REMARKS

ANNOTATED SHEET SHOWING CHANGES

ATTY DKT. NO.: INFN/SZ0028
 U.S. SERIAL NO.: 10/716,079
 FILED: NOVEMBER 18, 2003
 TITLE: LOW RISE/FALL SKEWED INPUT BUFFER COMPENSATING
 PROCESS VARIATION
 INVENTOR(S): JONGHEE HAN

FIG. 5

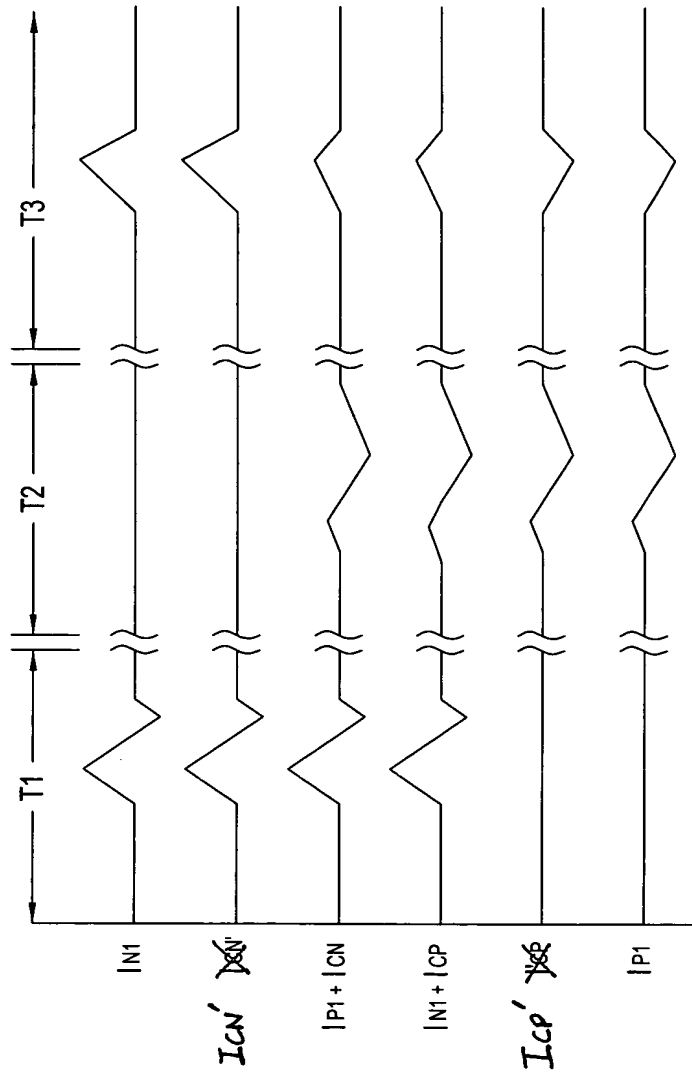
The attached sheet of drawings includes changes to Figure 4 and Figure 5.

The drawings are objected to because labels in the drawings are not consistent with the specification. Replacement sheets, submitted herewith, have revised the labels to be consistent with the specification. Accordingly, Applicant respectfully requests withdrawal of this objection.
